Re: Turkey Point Unit 4  
Docket No. 50-251  
Response to Request for Additional Information Regarding  
Steam Generator Tube Inspection Report

**Response to Request for Additional Information Regarding  
Unit 4 Steam Generator Tube Inspection Report**

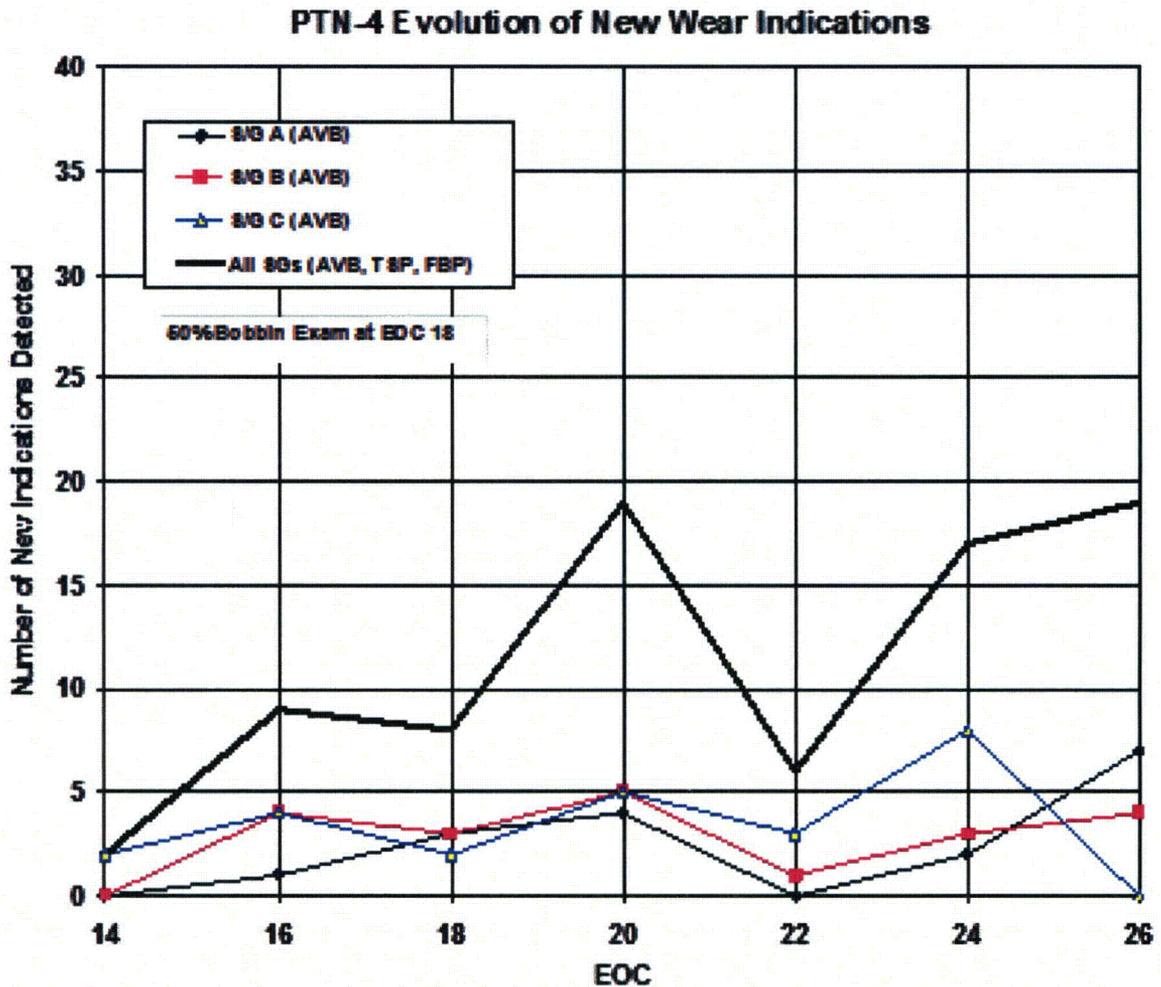
It appears that the number of new wear indications is increasing. Please discuss any insights on this trend.

The figure below shows the trend in new wear indications at Turkey Point Unit 4. The trend for all wear mechanisms has not been significantly increasing. For AVB wear only, the number of new wear indications is a weak function of operating time. The variability in the uniform trend is most likely due to the sensitivity of the NDE results to the probability of detection, which reflects both technique and analyst uncertainties.
